Subject: KNOCKING / SQUEAKING NOISE FROM FRONT STRUT BEARING	Bulletin No: 02-005/13
	Last Issued: 05/24/2013

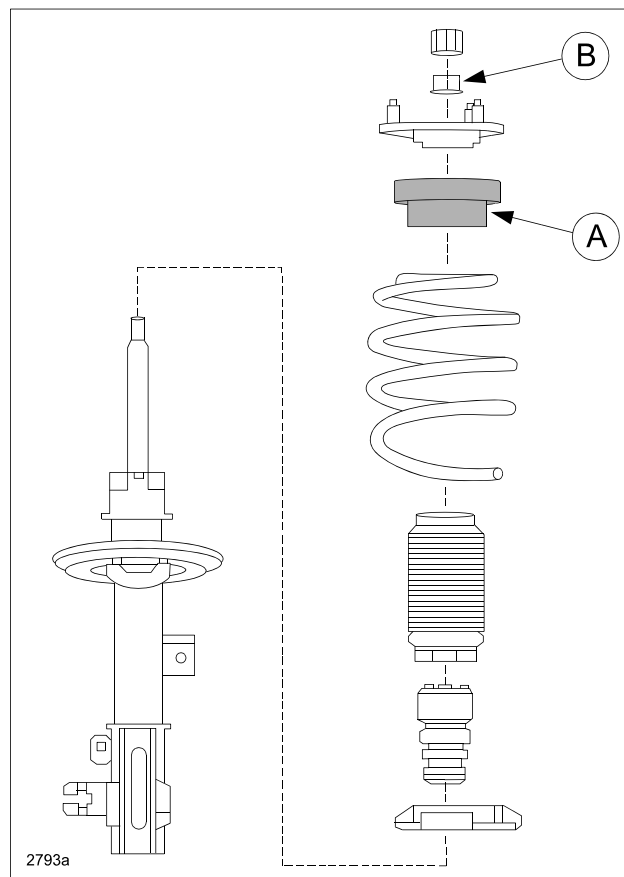
Some vehicles may exhibit a knocking / squeaking noise from the front strut bearing (A) due to front strut bearing damage when driving on rough roads and/or when turning the steering wheel while the vehicle is stopped.

The noise may be due to the upper housing of the front strut bearing being damaged when applying excessive force to the bearing during customer use. To eliminate the noise, the material and production method of the front strut bearing has been changed.

NOTE: The piston rod nut (B) requires replacement when the front strut bearing is replaced.

1. Verify the noise is coming from the upper part of front shock absorber when turning the steering wheel.
2. Replace the front strut bearing with a new one according to MS3 online instructions or the Workshop Manual (section 02-13 FRONT SHOCK ABSORBER AND COIL SPRING DISASSEMBLY/ASSEMBLY).
3. Verify repair.
